Comment on the Proposed Drilling Plan for LANL Characterization Wells R-35a and R-35b as Sentry Monitoring Wells for Los Alamos County Drinking Water Well PM-3 by Robert H. Gilkeson, Registered Geologist  
- A report presented to the March 14, 2007 Meeting of the Northern New Mexico Citizen's Advisory Board.

Figure 1. Map Showing the Locations of LANL Characterization Wells R-8, R-11, R-13, R-28, and the Los Alamos County Drinking Water Wells O-4 and PM-3.

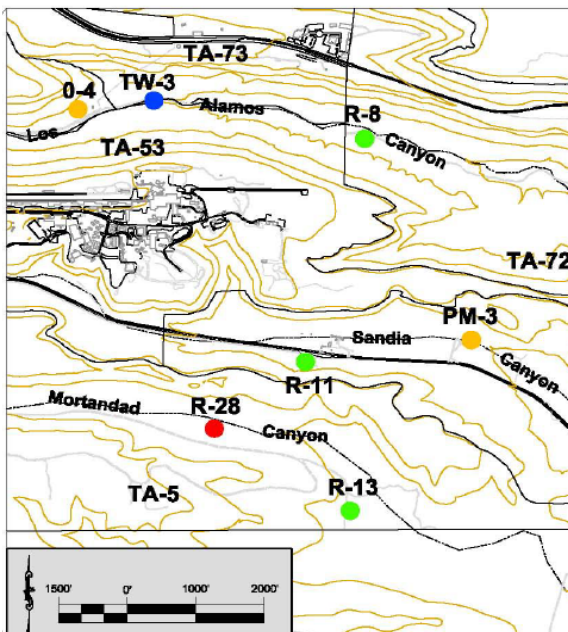
A major mistake in the LANL study of the chromium contamination is that a well to the regional aquifer was not installed at a location along Sandia Canyon where the recharge of the chromium contamination and other contamination including molybdenum and zinc to the regional aquifer occurred. Drinking water well O-4 is in danger of contamination by the recharge of waste water effluents along the floor of Sandia Canyon.

As shown on Figure 1, the property of the San Ildefonso Pueblo is ¼-mile to the south of well R-28. LANL well R-13 does not establish the lateral dimensions of the hexavalent chromium plume because the top of the well screen is 125 feet below the water table, and below confining beds of clayey sediments. It is very probable that the chromium plume is present in the highly permeable aquifer strata that are present at a shallow depth below the water table at the location of well R-13.

It is very probable that the chromium plume is contaminating the regional groundwater resource that is the property of the San Ildefonso Pueblo. It is also possible that the level of hexavalent chromium contamination is greater on the Pueblo property than is measured at well R-28. There is an immediate need to install a reliable monitoring well on the property of the San Ildefonso Pueblo at a location south of well R-28.
